# UNITED STATES PATENT AND TRADEMARK OFFICE

APPLICATION NO.	FILING DATE	FIRST NAMED INVENTOR	ATTORNEY DOCKET NO.	CONFIRMATION NO.
10/712,362	11/13/2003	Gregory P. Muldowney	03031US	1443
7590	08/09/2005		EXAMINER	
Rodel Holdings, Inc. Suite 1300 1105 North Market Street Wilmington, DE 19899			SHAKERI, HADI	
			ART UNIT	PAPER NUMBER
			3723

<b>Office Action Summary</b>	<b>Application No.</b>	<b>Applicant(s)</b>	
	10/712,362	MULDOWNEY, GREGORY P.	
	Examiner Hadi Shakeri	<b>Art Unit</b> 3723

**DETAILED ACTION*****Claim Rejections - 35 USC § 102***

FIG. 13

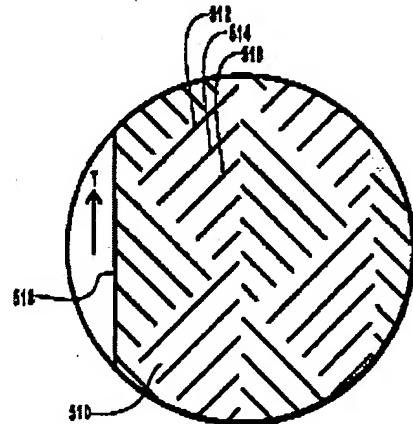
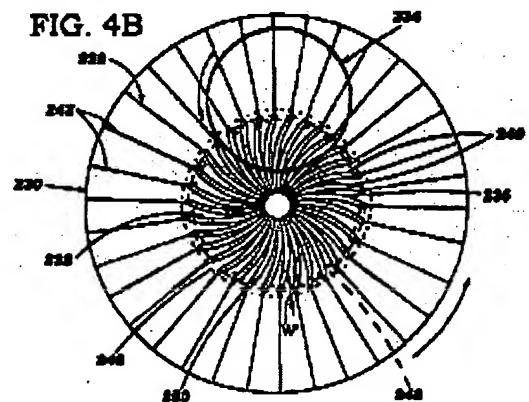
The argument that Robinson does not disclose a first plurality of grooves having a second end that is radially inward of the outer peripheral edge is not persuasive. Robinson in Fig. 13 discloses a first groove (512-516) that have a second end "not terminating at the peripheral edge" and a set of second grooves (either one of the other sets not labeled by 512-516) that meet the limitations, and secondly the embodiment as shown in Fig. 7, also meets the limitation since the second end of the first set of grooves is "radially inward of the outer peripheral edge", it may be terminating at it but still reads over the limitations to be radially inward, i.e., it does not extend beyond it.
